Access Compliance Report

Public Rights-of-Way

Intersection ID: 49315	Main Street: ANNA_JORDAN_DR	Cross Street: ROCKLAND_DR	Location: NW
ADA ID: 85B7BB697714	Ramp Type: PerpDiag	Initial Pass/Fail: Fail	Overall Compliance: No
		Severity Score: 8.75

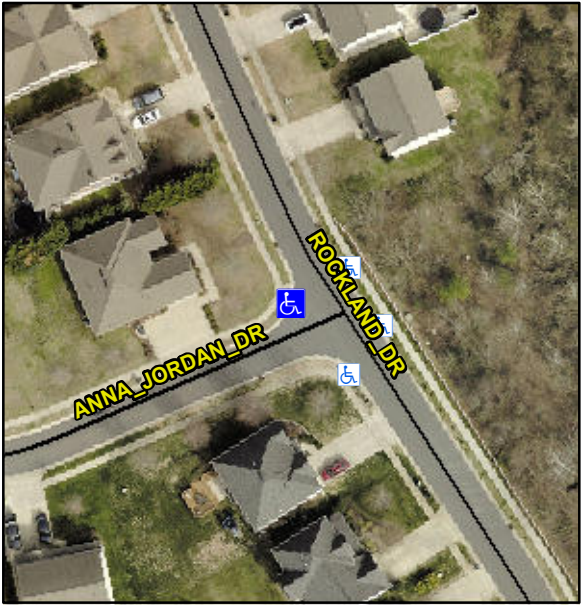
Codes/Mitigation Info/Possible Solution			Field Measurements/Component Compliance		
	Possible Solutions:		Compliance	Description	Data
	Remove & Replace Curb Ramp With Two New Directional Ramps or Equivalent.		Yes	Ramp Length (in)	6.0
			No	Ramp Width (in)	0.7
			N/A	Flare Type LT	N/A
			N/A	Flare Slope LT (%)	N/A
			N/A	Flare Traversable LT?	N/A
			N/A	Landing Length (in)	N/A
			N/A	Landing Width (in)	N/A
			N/A	Landing Slope (%)	N/A
			N/A	Landing X Slope (%)	N/A
<p>Surveyor Notes:</p> <p>N/A</p> <p>PROW/ADA:</p> <p>Not Found, R304.5.1</p>			N/A	Flare Type RT	N/A
			N/A	Flare Slope RT (%)	N/A
			N/A	Flare Traversable RT?	N/A
			N/A	DWS Provided?	N/A
			N/A	DWS Contrast?	N/A
			N/A	DWS Length (in)	N/A
			N/A	DWS Full Width?	N/A
			N/A	DWS Offset (in)	N/A
			N/A	Gutter Ponding?	N/A
			N/A	Gutter Lip Ht (in)	N/A
			No	Painted X Walk1?	No
				X Walk 1 Direction	To S
			N/A	X Walk 1 Width (in)	N/A

1.3	X Walk 1 Slope (%)	2.1
			0.7	X Walk 1 X Slope (%)	3.2
			N/A	Ramp inside XWalk1?	N/A
			1.4	Road Slope (%)	N/A
			0.2	Road X Slope (%)	N/A
			N/A	Any Obstructions?	N/A
				Obstruction Type	
Total Cost:		\$ 3200.00	N/A	Storm Grate/Utility Hazard?	N/A
			N/A	Storm Grate/Utility Type	N/A
			Yes	Surface Condition? (G/P)	Good
